**RE: Wilton Inland Wetlands and Watercourses Agency Review
Application for a Significant Regulated Activity
Application #2904(S) ASML Acquisitions, LLC
131 Danbury Road, Wilton, Connecticut**

Review comments related to the Site Plans and Engineering Reports February 29, 2024

DEWATERING UNDERDRAIN

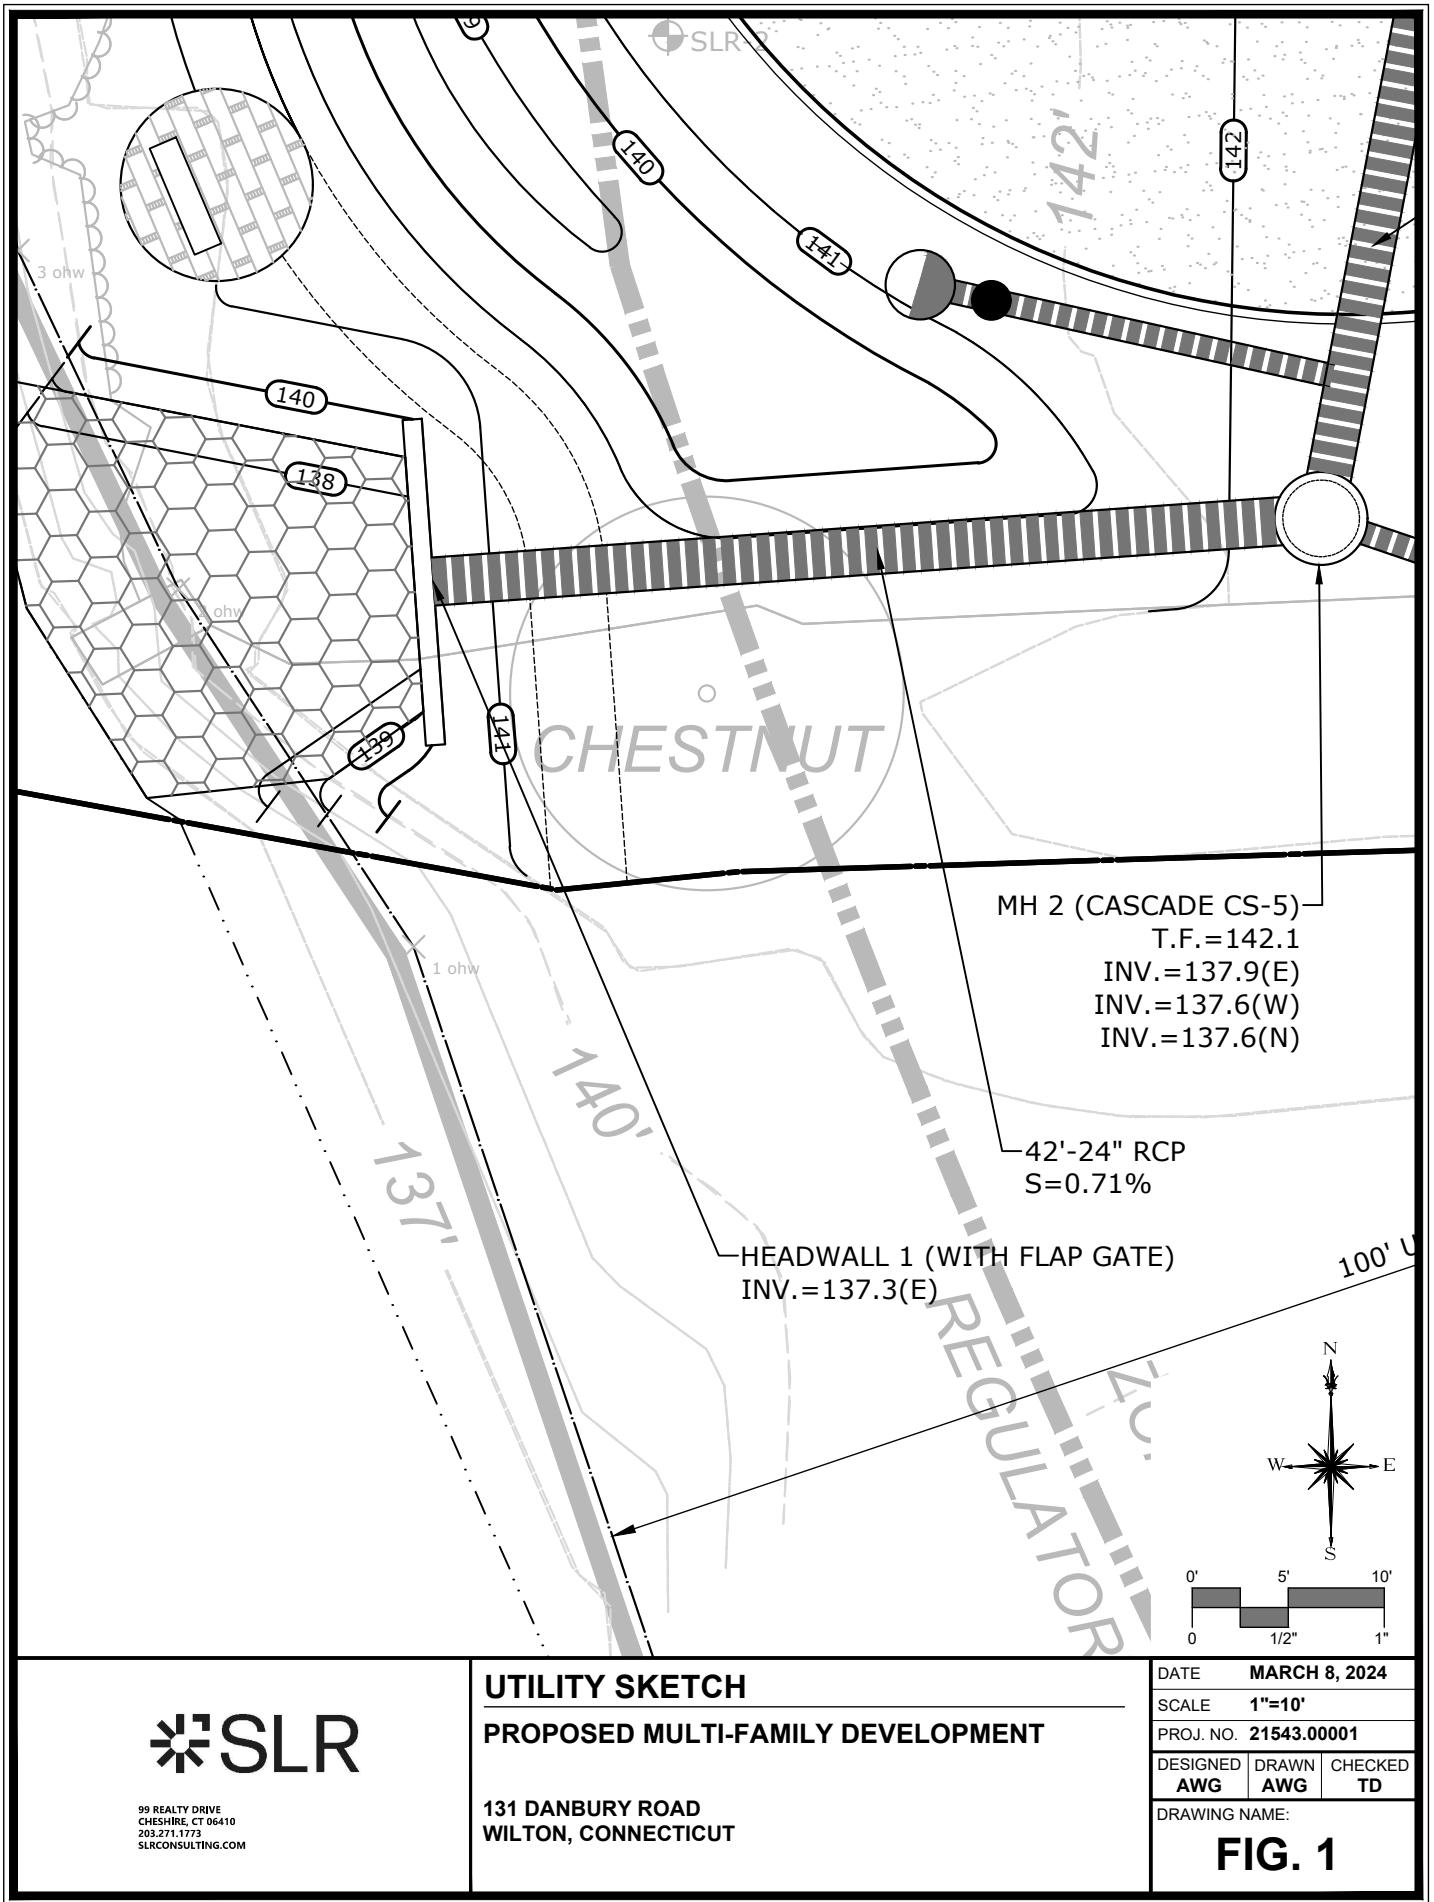
- R.CC-GR-20: Underdrain will be added to the basin in SW corner for the final submission, along with an underdrain detail. See attached detail which will be added to the final plan.

SEDIMENT AND EROSION CONTROL PLAN			
PROPOSED MULTI-FAMILY DEVELOPMENT			
131 DANBURY ROAD WILTON, CONNECTICUT			
AWG DESIGNED	AWG DRAWN	TD CHECKED	
SCALE 1"=20'			
DATE OCTOBER 23, 2023			
PROJECT NO. 21543.00001			
SHEET NO. 09 OF 25			
SE-1

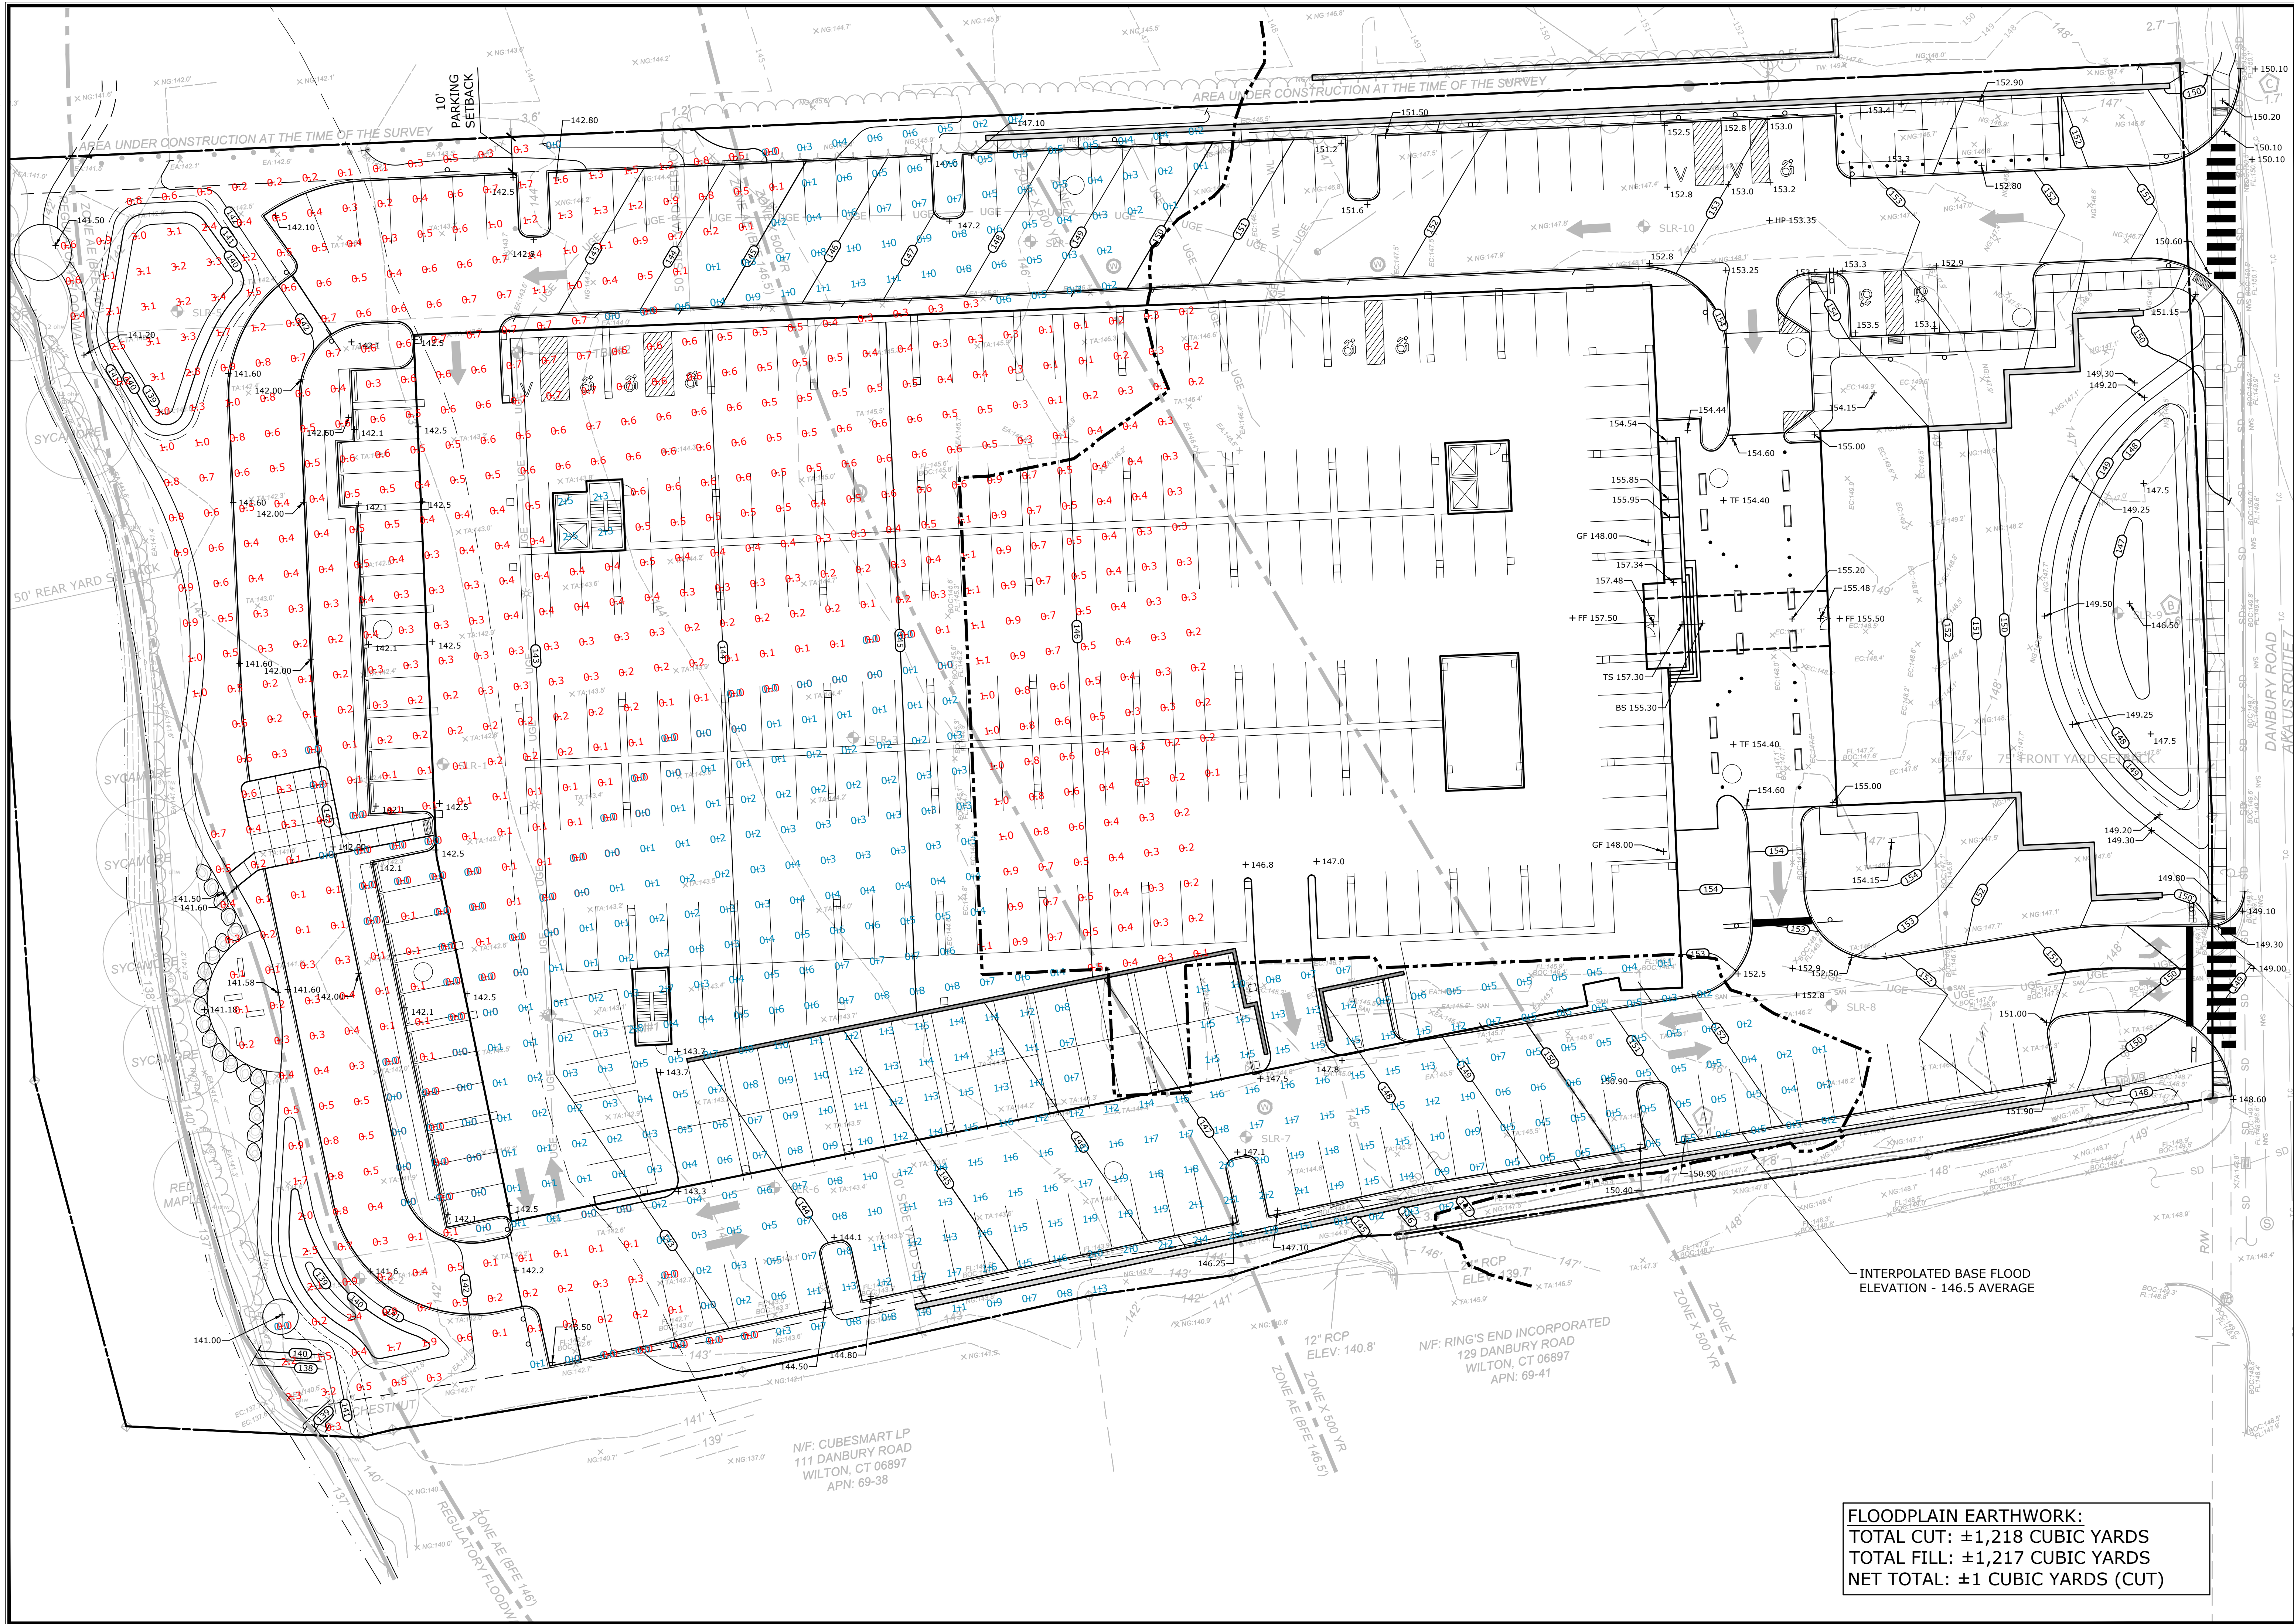
R.4: The sediment and erosion control plan has been revised and is attached. It includes a construction sequence for the storm drainage outlet as presented at the Inland Wetlands Commission meeting on March 6, 2024. Furthermore the silt fence along the river has been called out as wire mesh backed silt fence

- R.CC-SE-1-4: See updated sheet SE-1 attached. Relevant details for staked coir logs, wire backed silt fence and turbidity curtain will be added to the final plans.

- R.CC-SE-1-9: See updated sheet SE-1 attached. Relevant details for staked coir logs, wire backed silt fence and turbidity curtain will be added to the final plans.
